ADDENDUM No. 1

PROJECT MANAGEMENT - PUBLIC SERVICES - CITY OF ANN ARBOR  
GEDES AVENUE IMPROVEMENTS  
PROJECT DETAILS  
INFILTRATION DETAILS

PROJECT MANAGEMENT - PUBLIC SERVICES - CITY OF ANN ARBOR  
GEDDES AVENUE IMPROVEMENTS  
GEDDES AVENUE TYPICAL SECTIONS  
P.O.B. TO 23+75

PROJECT MANAGEMENT - PUBLIC SERVICES - CITY OF ANN ARBOR  
 GEDDES AVENUE IMPROVEMENTS  
 REMOVALS  
 GEDDES AVENUE STA. 26+50 TO STA. 42+50  
 PATH STA. 1+00 TO 6+04

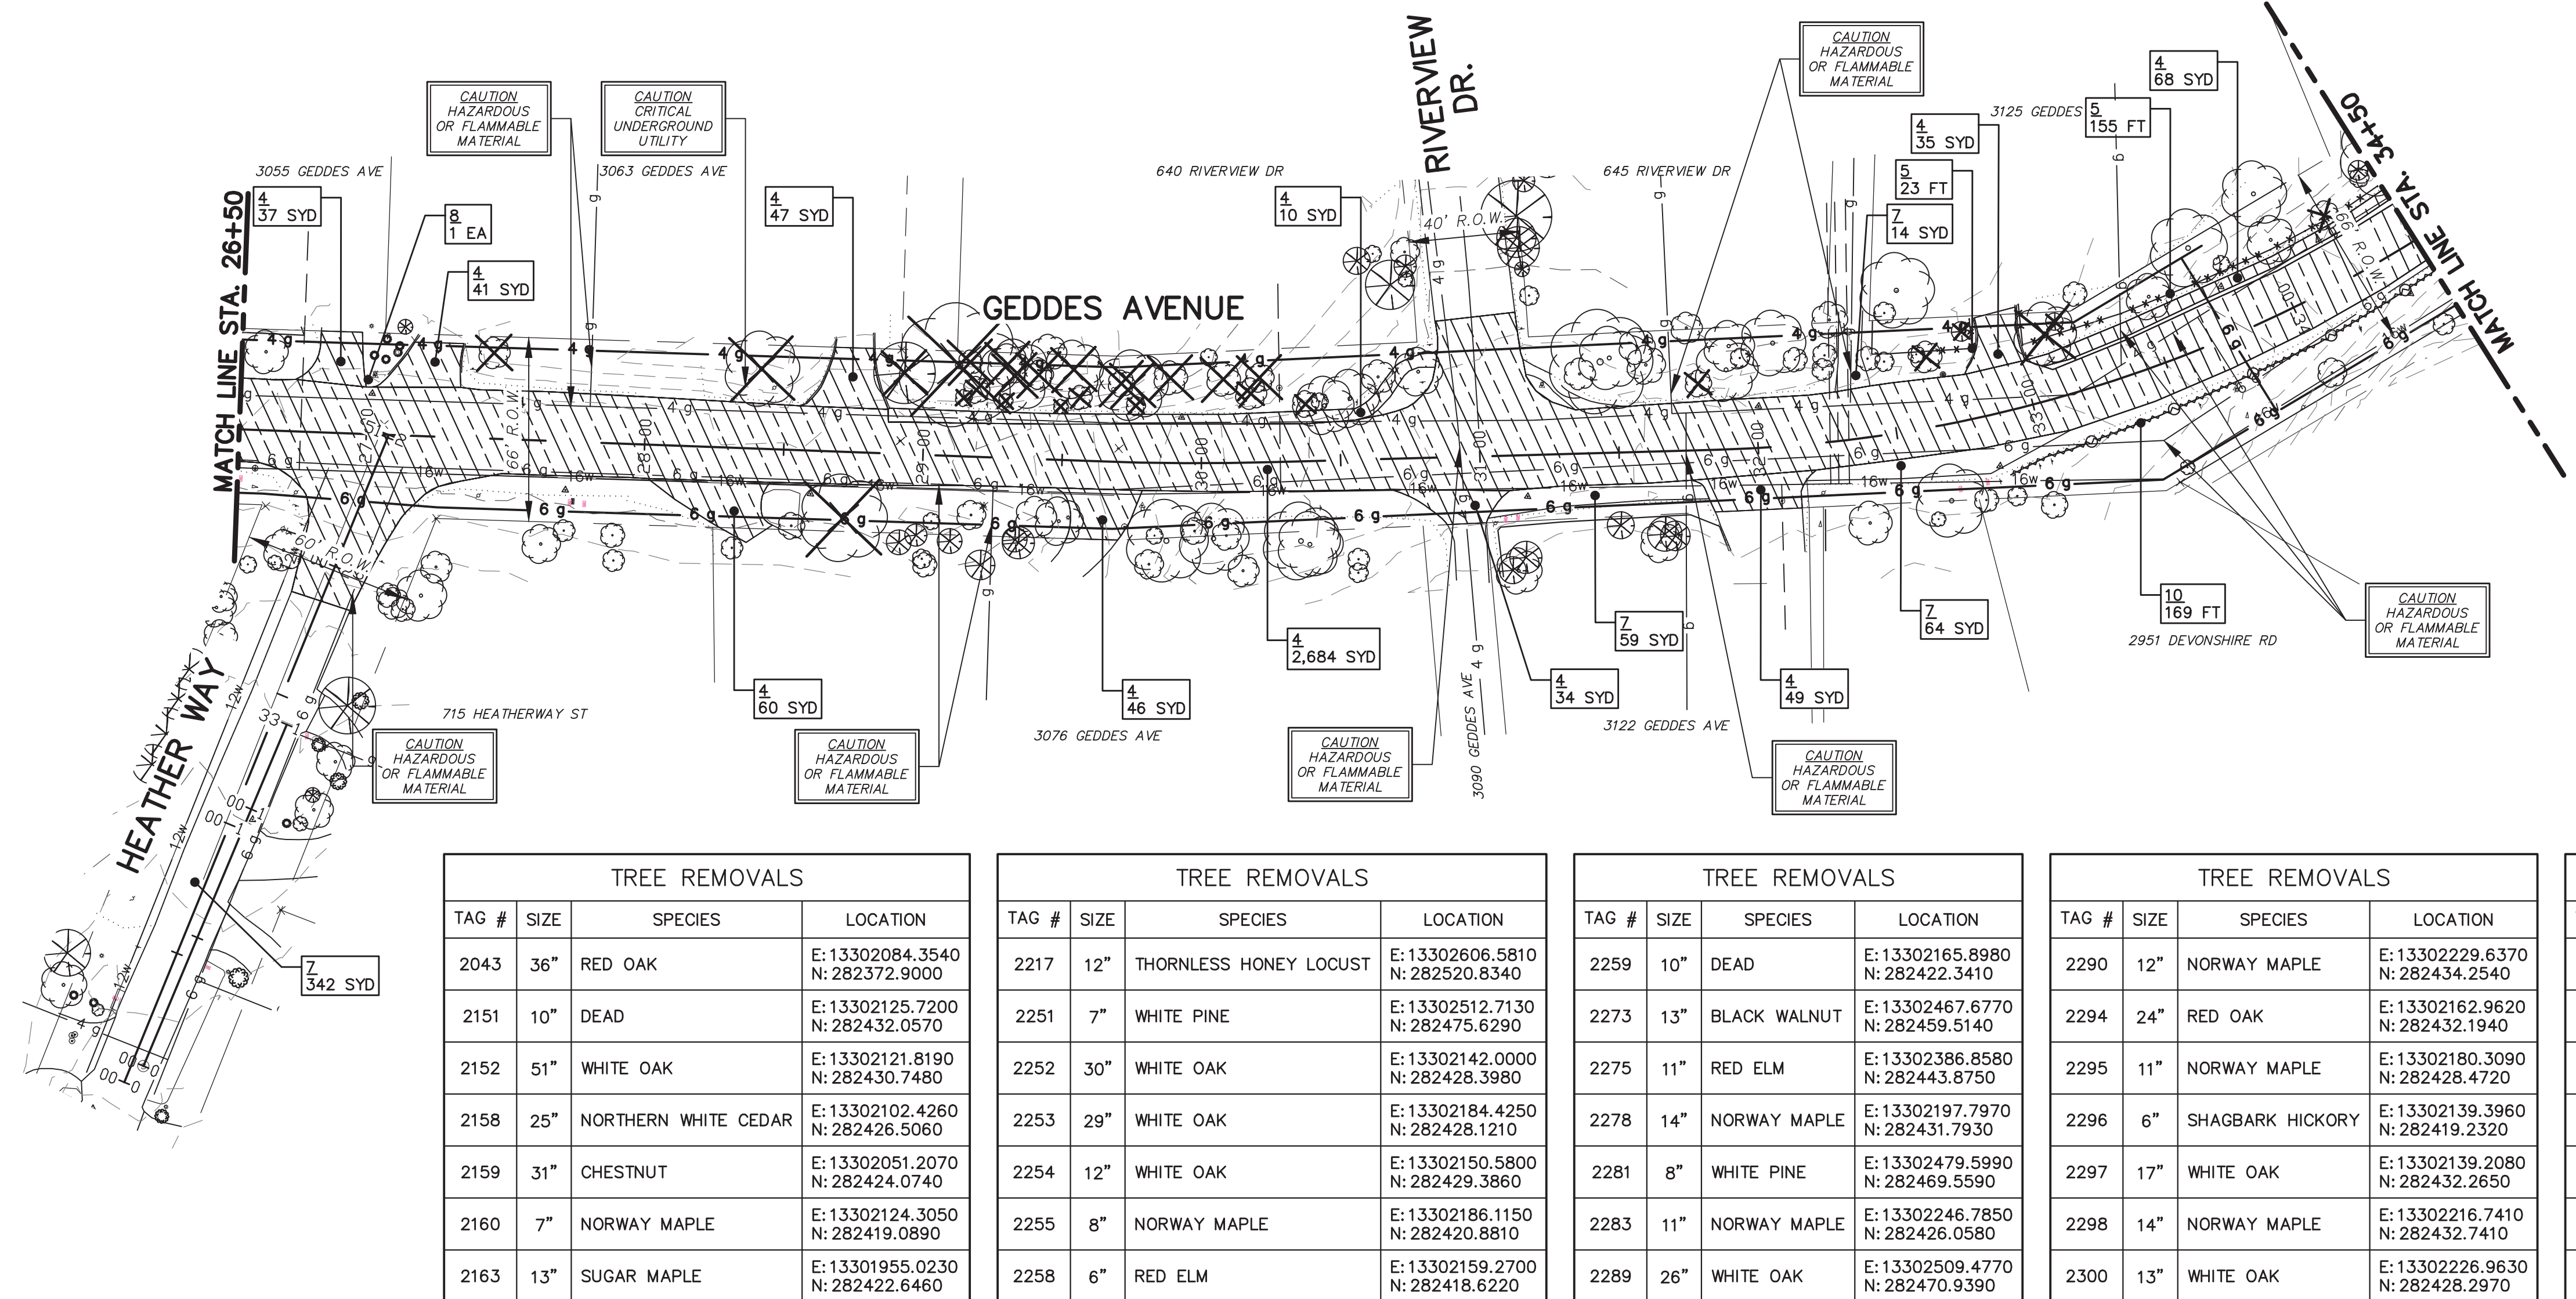
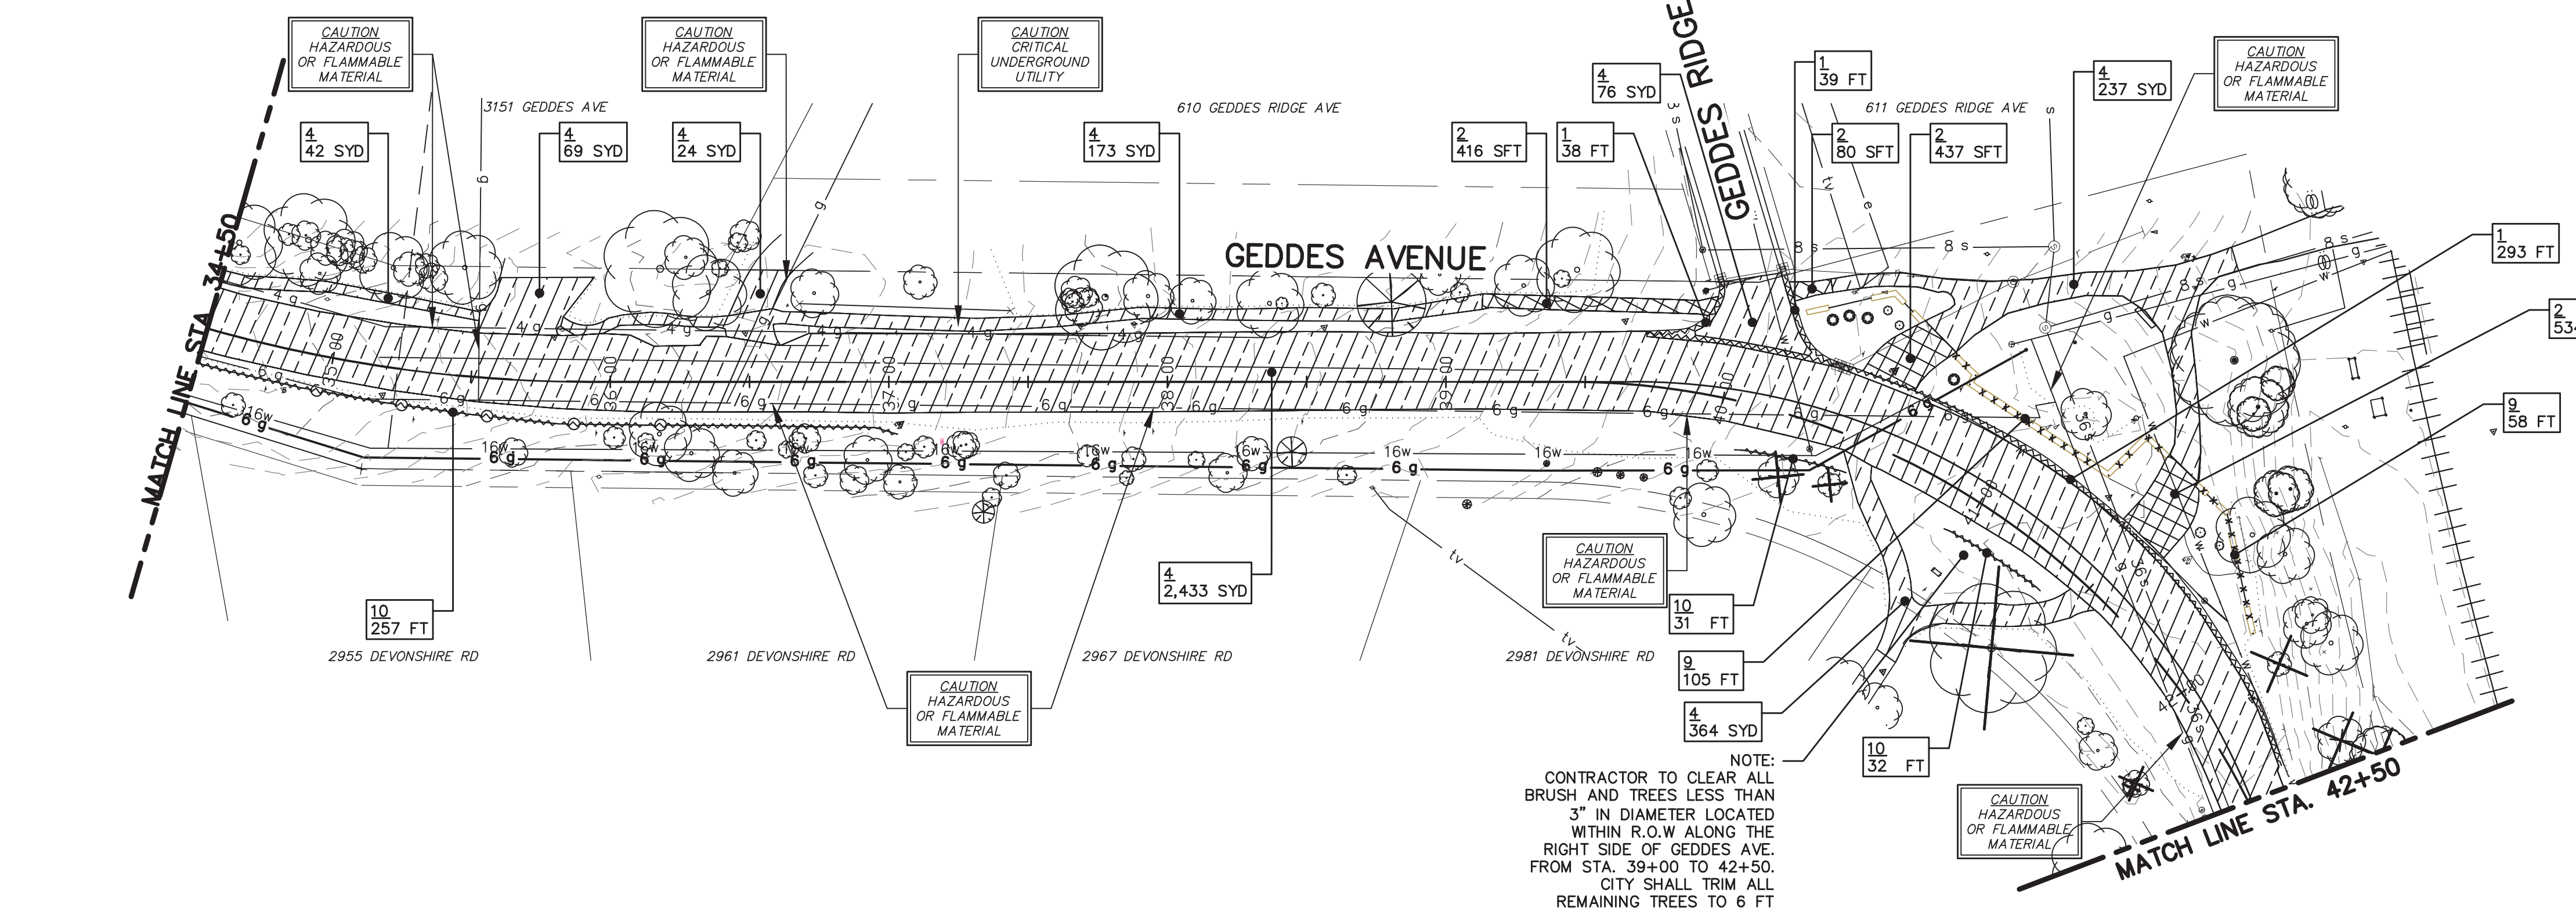
UPDATED TREE REMOVAL TABLES.

1 UPDATED TREE REMOVAL TABLES.

REMOVALS

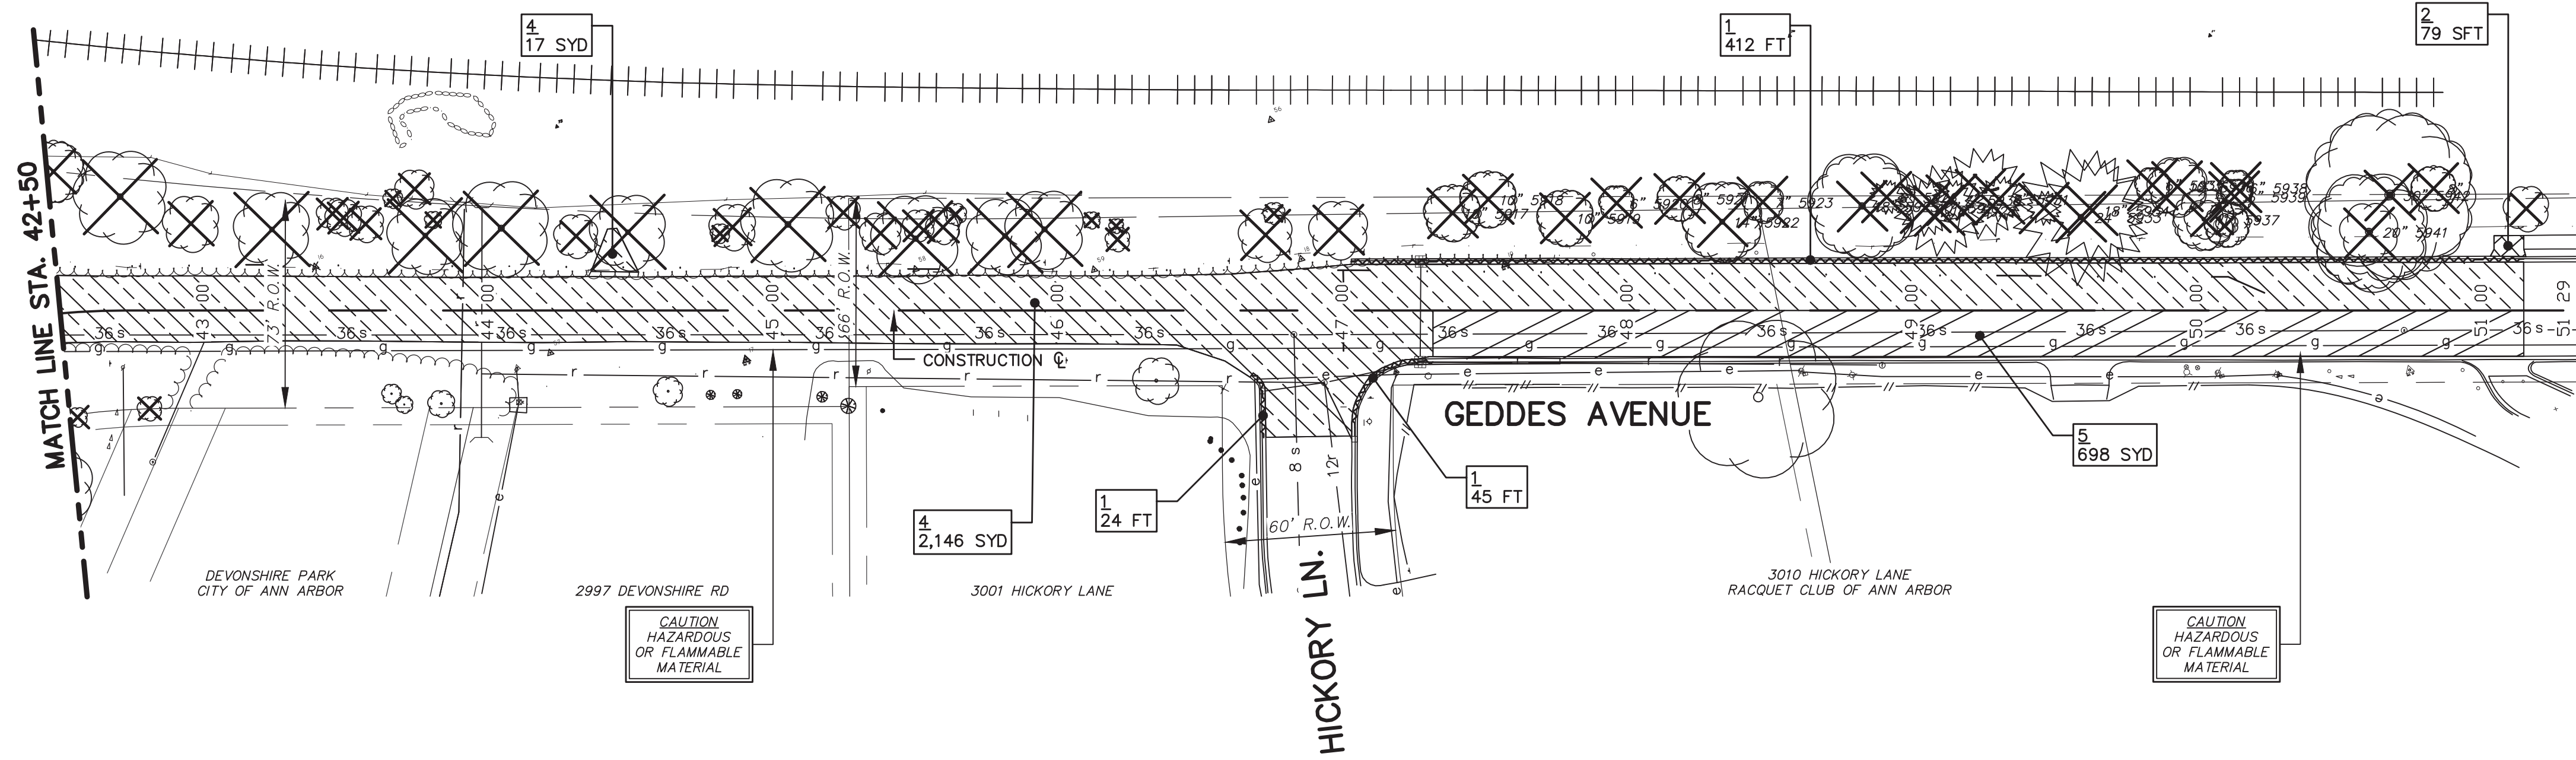
1 UPDATED TREE REMOVAL TABLES.
